**BOARD ACTION REPORT – APPEALABLE ITEM**

**Project Name:** Delray Ford  
**Project Location:** 2501 South Federal Highway  
**Request:** Class V Site Plan, Landscape Plan, and Architectural Elevations.

STAFF REPORT

AGENDA ITEM: Delray Ford (File #2017-034) – Class V Site Plan, Landscape Plan and Architectural Elevations associated with the construction of a 50,662 square foot automobile dealership at 2501 Federal Highway.

SITE PLAN  
DELRAY BEACH FORD  
2501 SOUTH FEDERAL HIGHWAY  
DELRAY BEACH, FLORIDA 33483  
CITY OF DELRAY BEACH  
PALM BEACH COUNTY

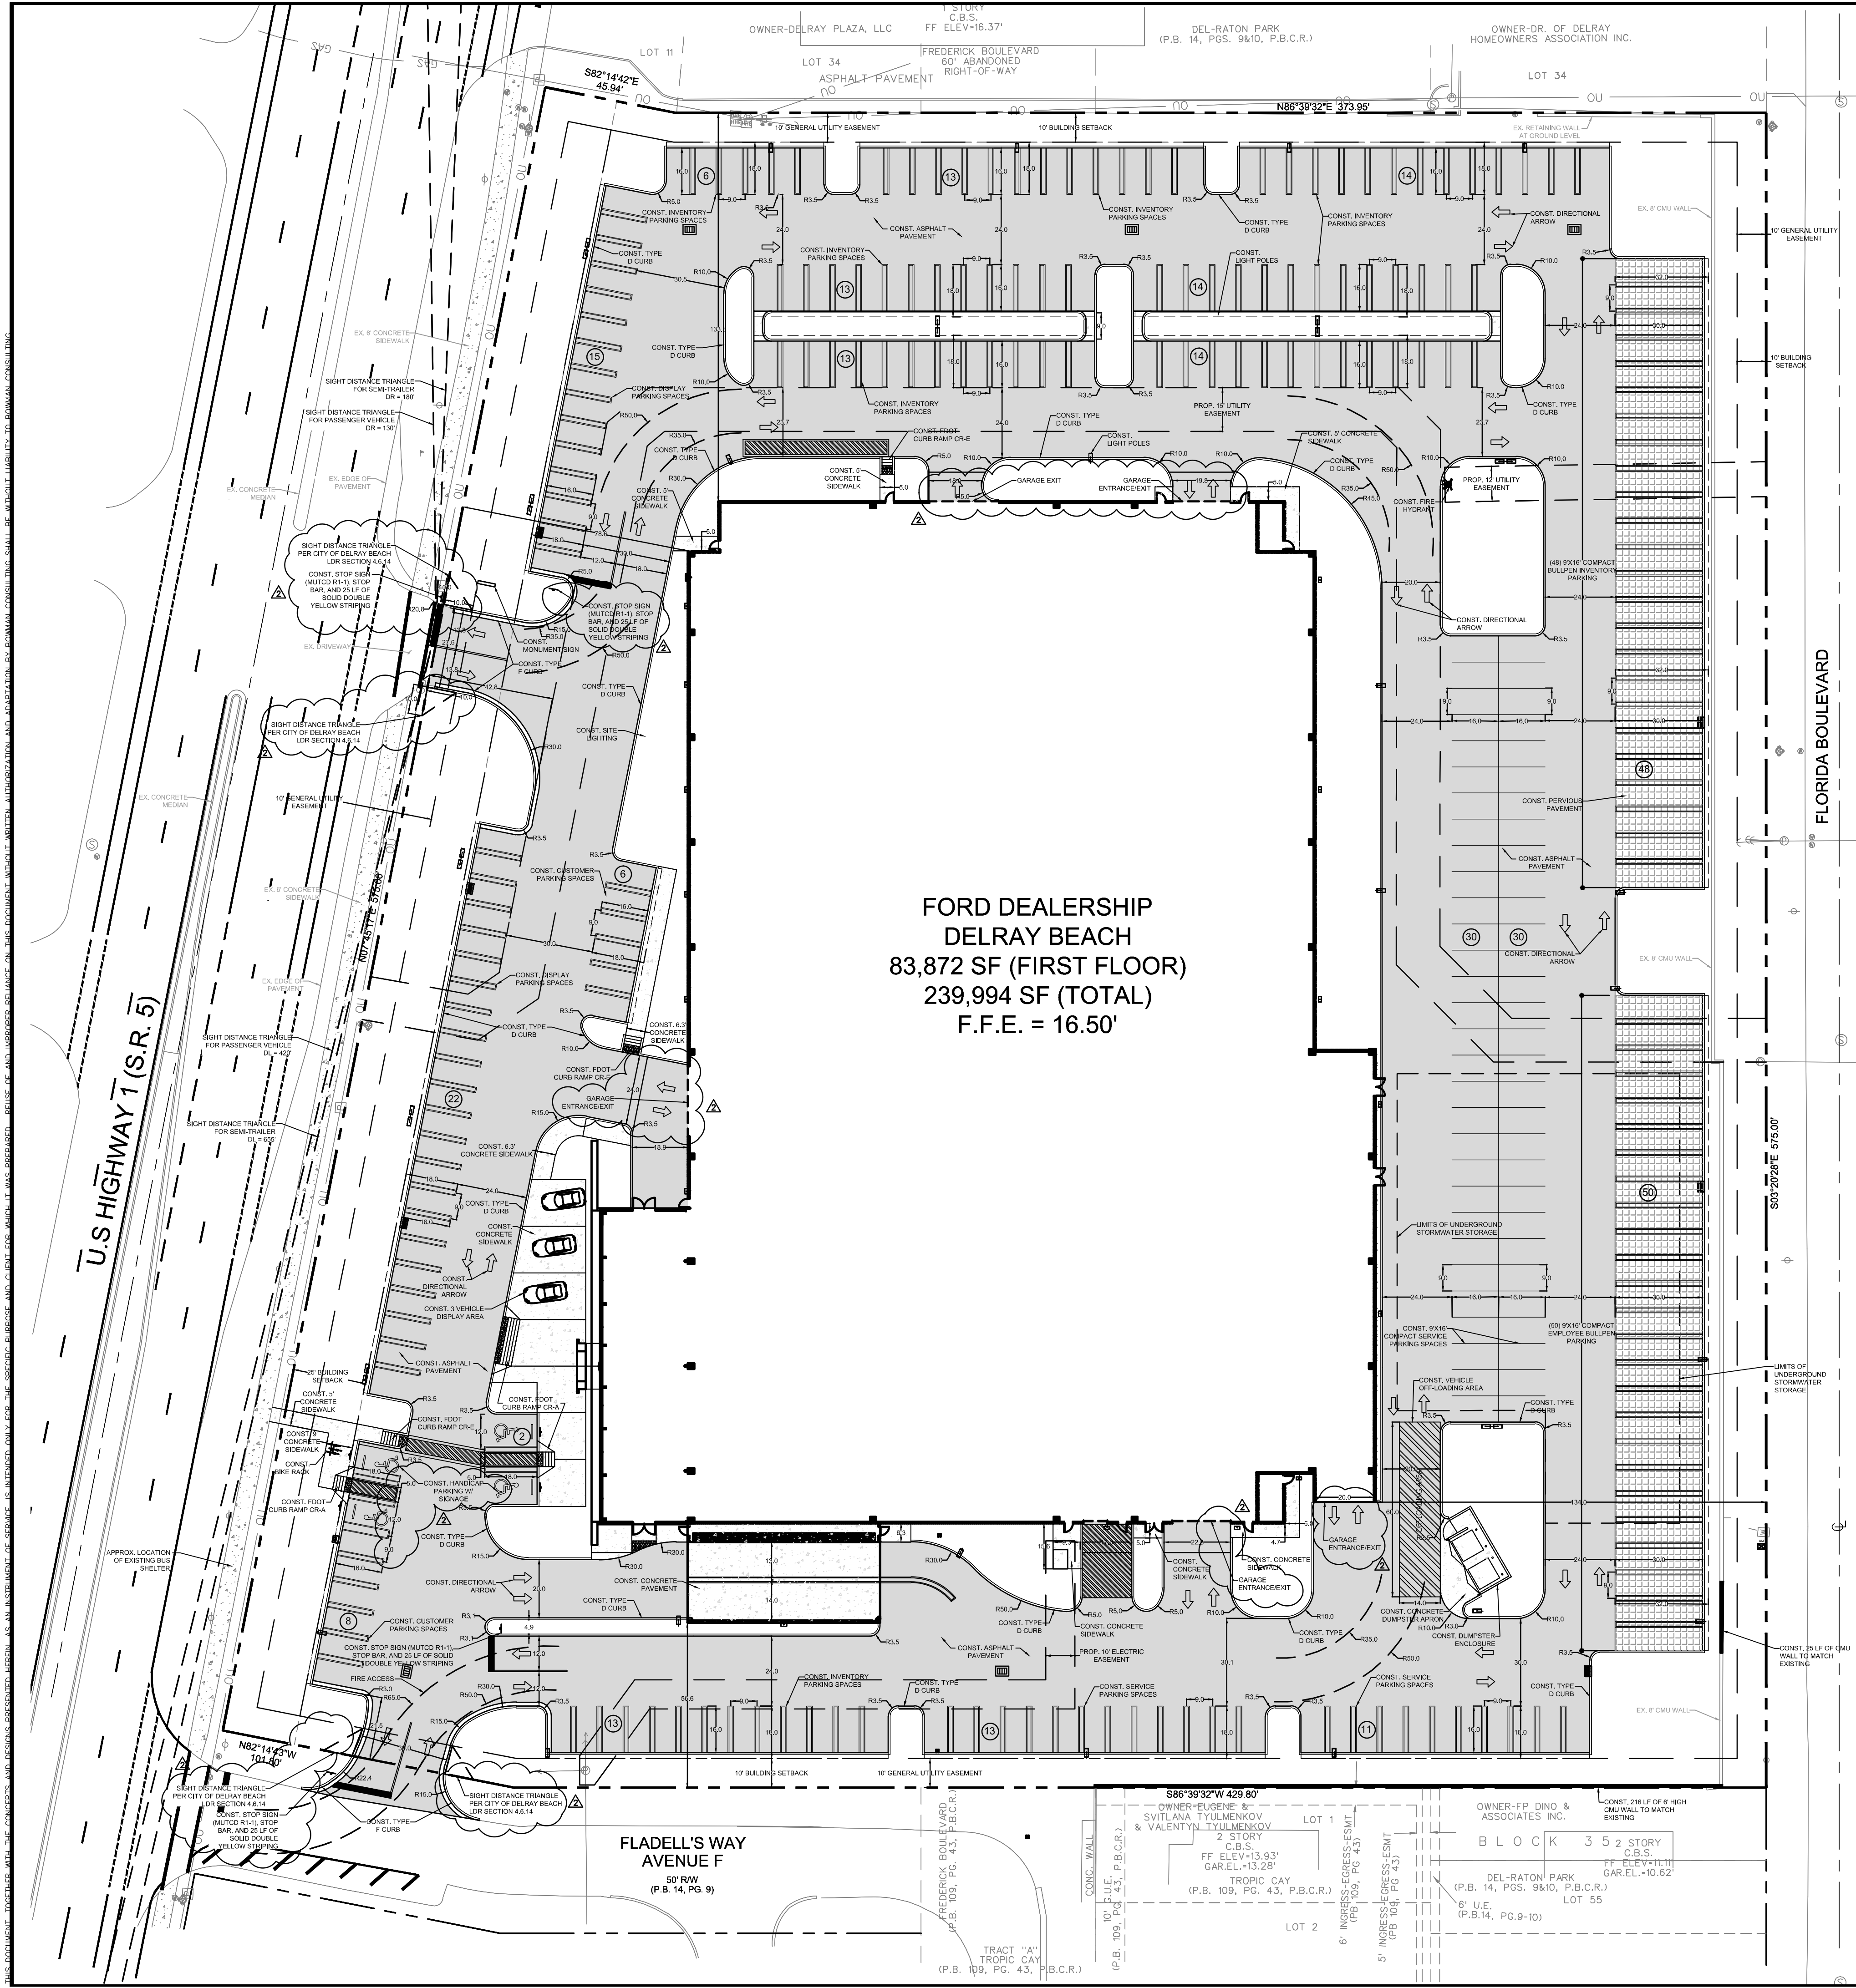
1. That a six foot masonry wall be provided along the northern property line, adjacent to the residential parcel;
2. That the dedicated off-loading area be relocated, in compliance with the residential setback;
3. That a loading demand study be submitted which justifies the reduced number of off-street loading areas;
4. That the overhead doors remain closed unless a vehicle is entering or exiting the structure;
5. That no outdoor loud speakers be permitted as part of this site plan approval, based on the proximity to residential developments;
6. That a portion of the 185 surface spaces (27 spaces) be reallocated for customer, employee, and/or service use to equal a minimum total of 152 spaces; and,
7. That a finding of concurrency be submitted from Palm Beach County Traffic Division prior to site plan certification.

A- 6.1

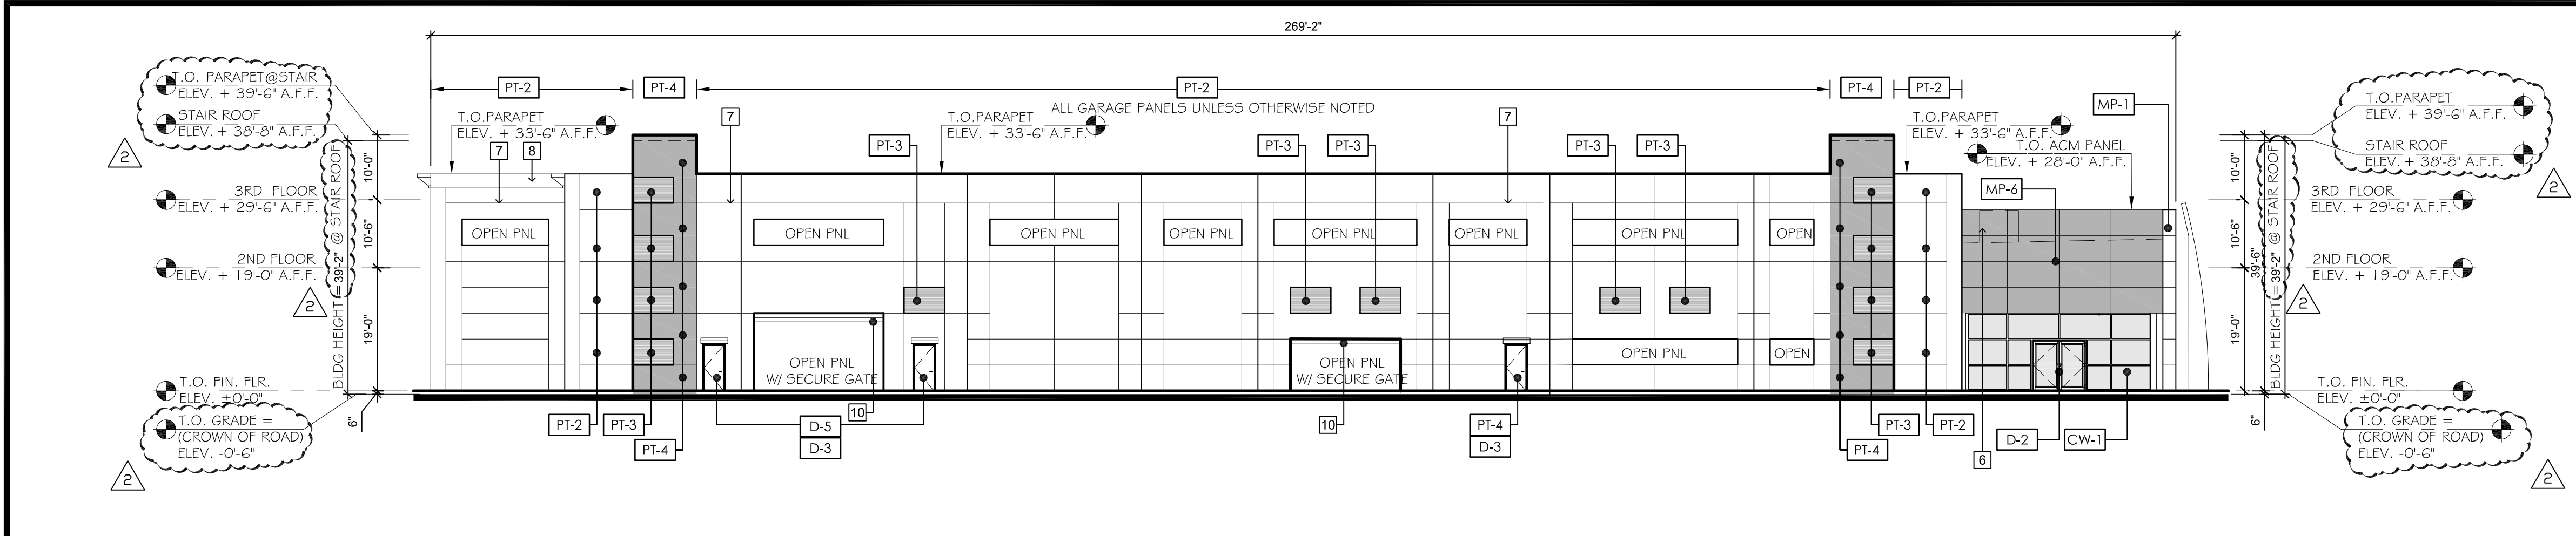
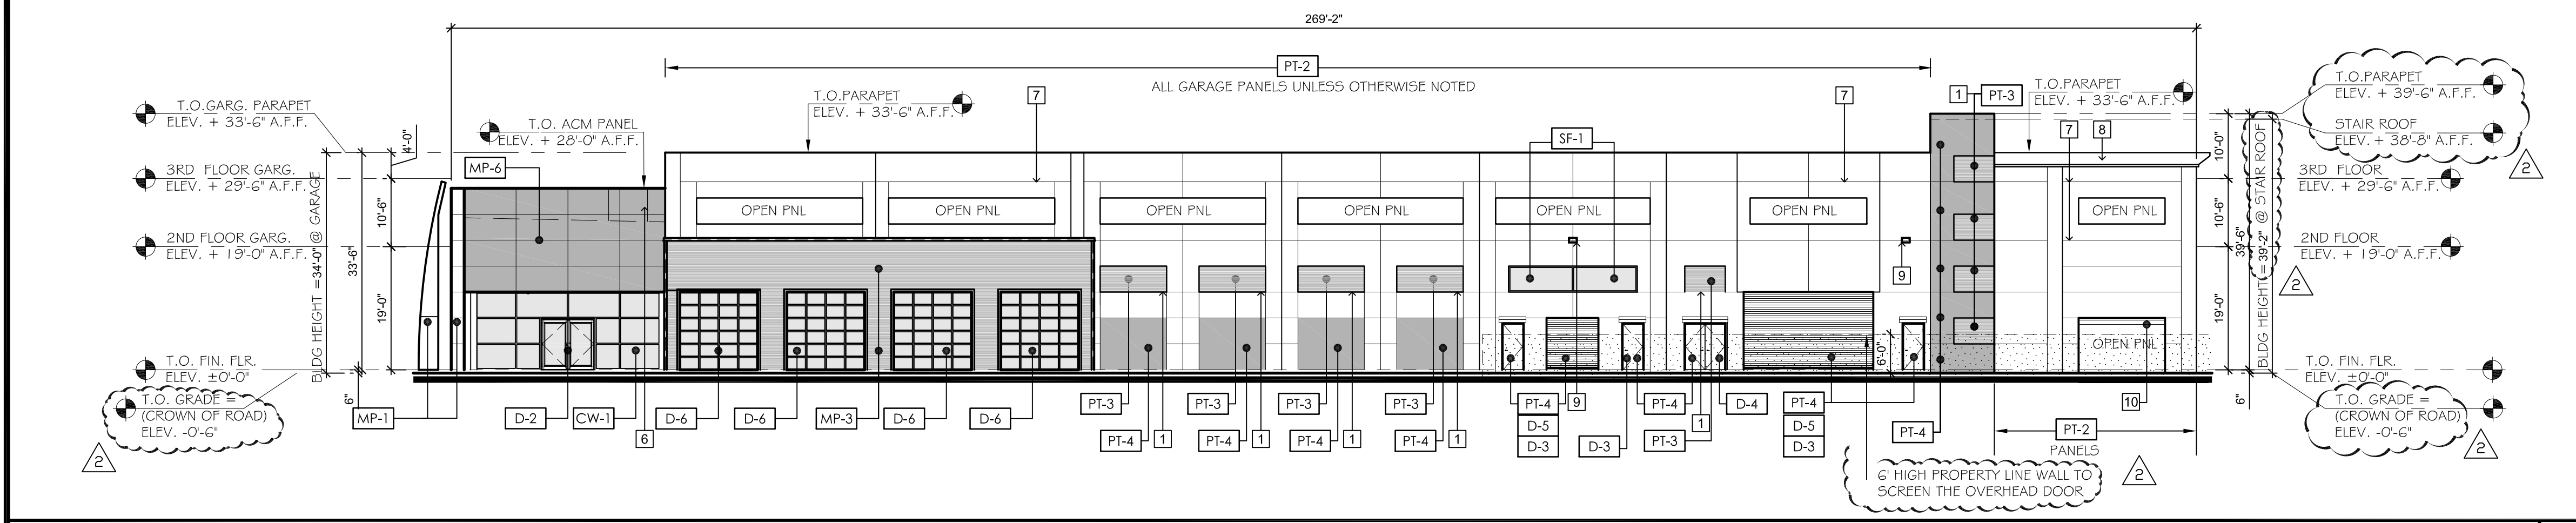
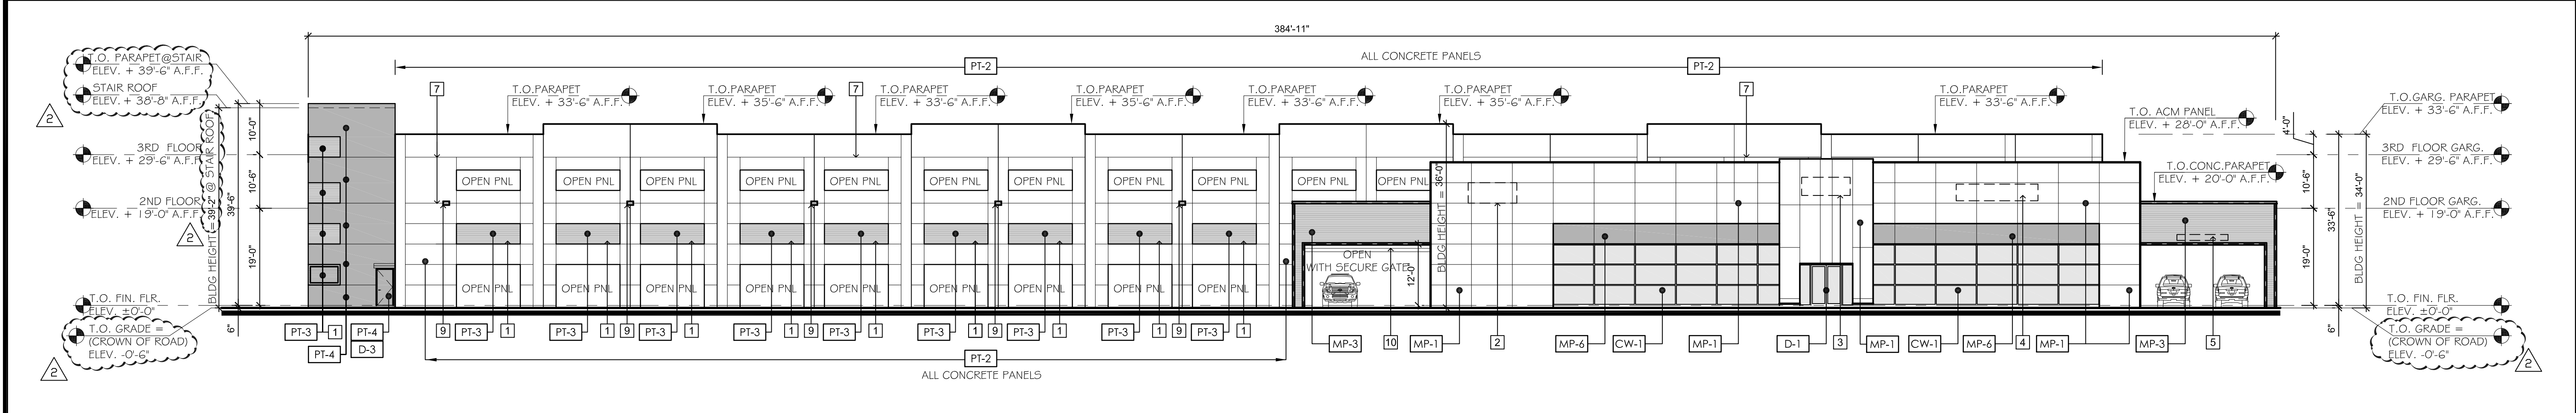
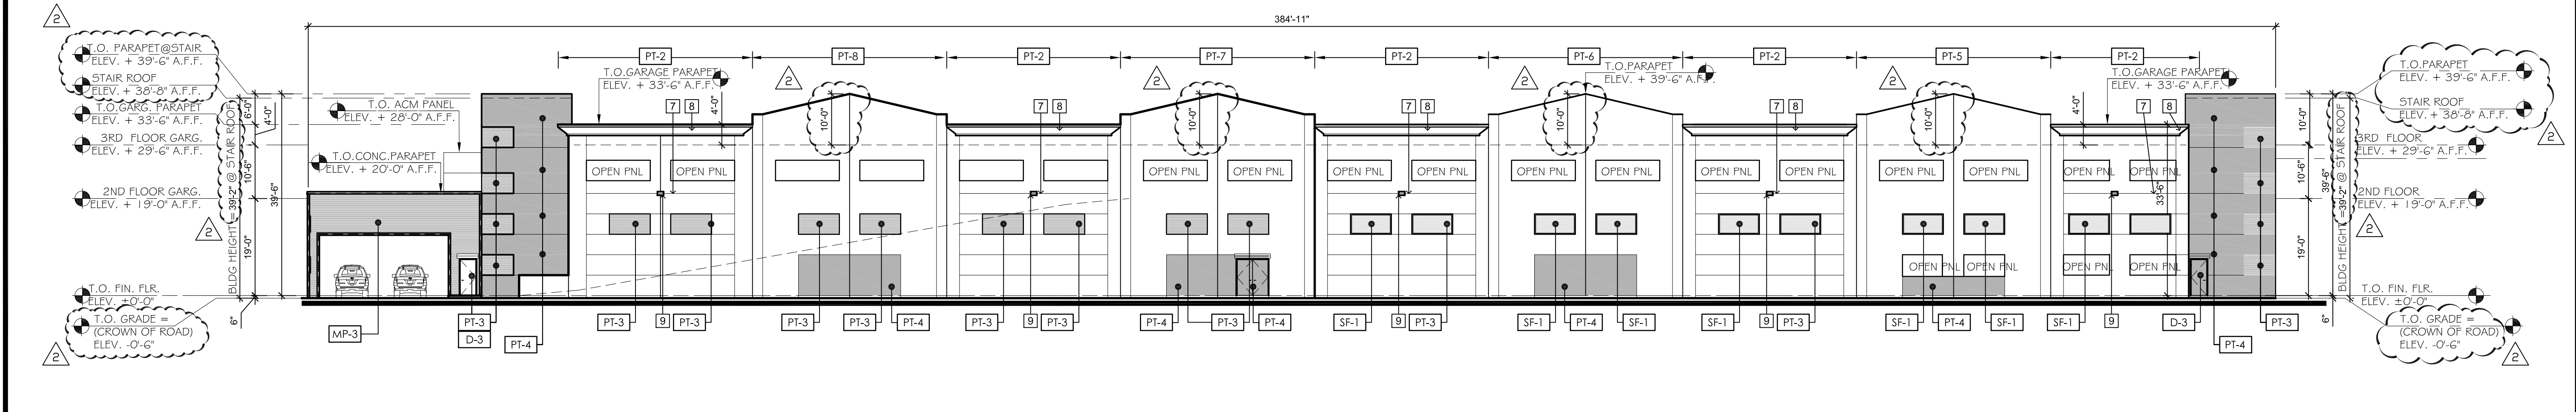
The applicant proposes bay doors along the south and north façades both of which face RM zoned properties. The intent of the subject requirement is to eliminate the exposure of service type uses which can be noisy and unsightly to adjacent residential development; however, the proposed uses behind the overhead doors are not auto service uses. The applicant provided a justification statement satisfying the requirement above and notes the doors will be "speed-doors" and will remain closed unless cars are entering and/or exiting. Therefore, the provision of overhead doors on these facades is supportable.

The proposed building is modern in appearance with primarily straight lines and a stylistically appropriate level of embellishment. This style is consistent with the use and surrounding development of the same nature. A neutral color palette is used with the exception of the rear façade, which strategically incorporates historically residential colors (pale blue, pink, yellow, and green) to relate to the surrounding neighborhood. Glass and ribbed metal panels are used as accents to the primarily masonry structure.

The roof height is varied to avoid a continuous roofline. The flat roof includes parapets to hide the rooftop inventory parking and mechanical equipment. Portions of the parapet are decorative with additional detail, and the rear façade incorporates slopped parapets that mimic residential rooftops. The break in flat lines is intended to reflect the building's context and is considered a favorable design addition.
